OHIO DEPARTMENT OF TRANSPORTATION
CENTRAL OFFICE, 1980 W. BROAD ST., COLUMBUS, OHIO 43216-0899

Re: 2015 Third Quarter Revisions

Summary of Revisions to the July 2007 ODOT BDM

FIGURE 302.5.2.3-2

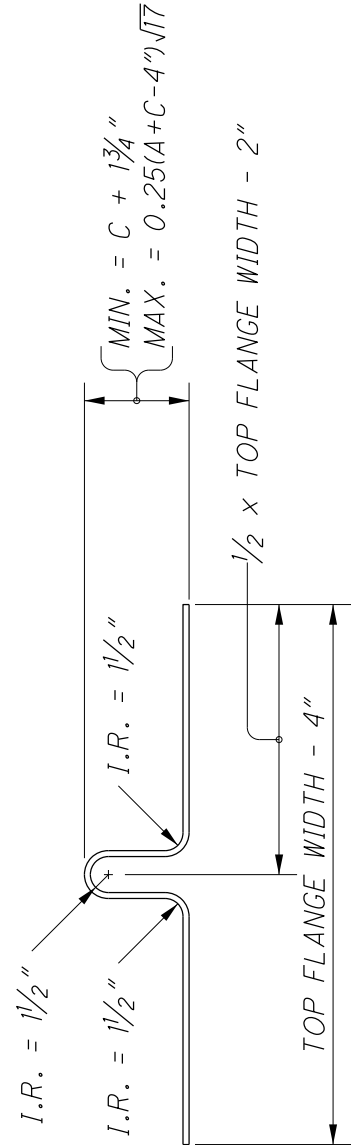
302.5.1.4	3-39	Our office is eliminating the use of Type D waterproofing for non-composite box beam bridges. The Type D is more labor intensive to install with little to no benefit compared to Type 3 waterproofing.
Figure 302.5.2.3-2		The equation for the max height of the #4 supplemental haunch bar was corrected for a math error.

NOTE - THE SUPPLEMENTAL HAUNCH BAR IS NOT REQUIRED WHERE $C < 4"$.

Figure 702.9-1

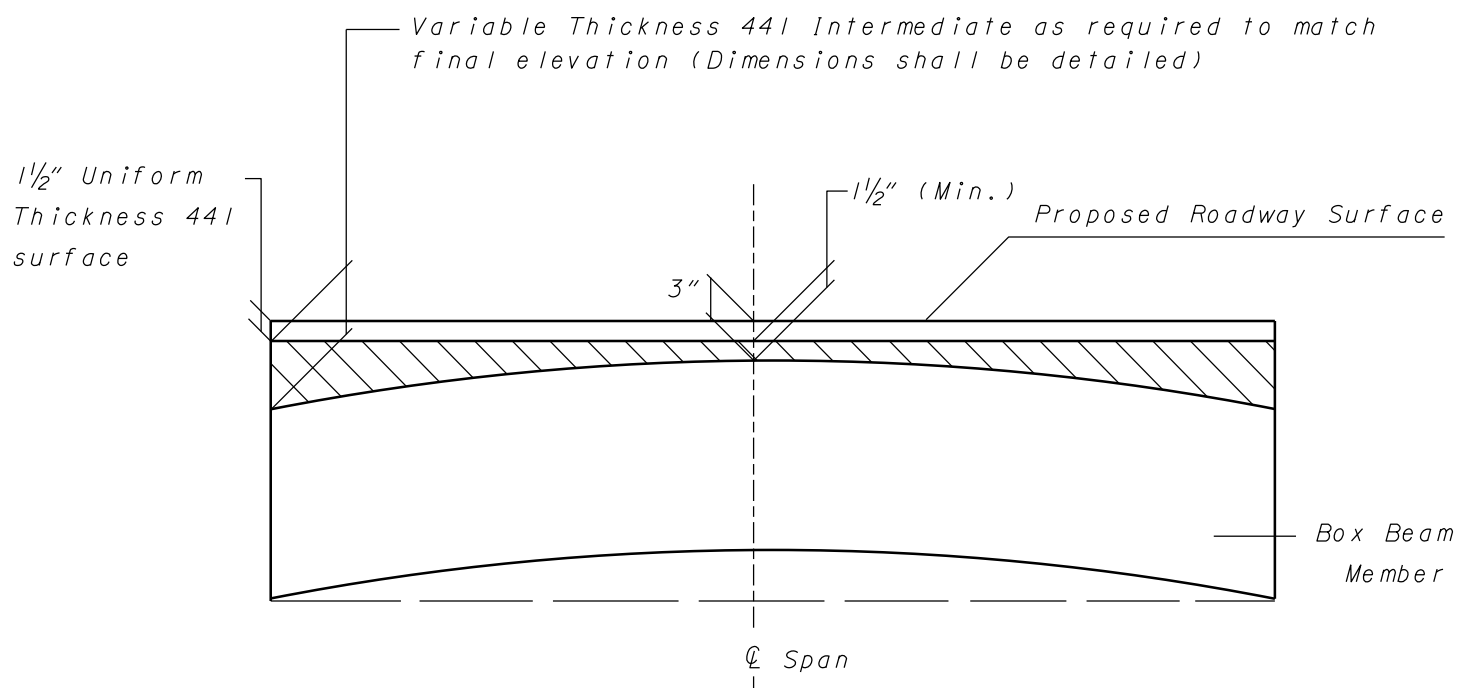
702.6.2	7-5 through 7-6	With the release of PSID-1-13, there has been confusion on locating construction joints for diaphragms and decks. These revisions help clarify the placement options for semi-integral diaphragms with regard to skew and phased construction.
Figure 702.9-1		This figure has been updated to reflect the replacement of Item 448 with Item 441. Also, the dimensions for intermediate and surface courses has been clarified.
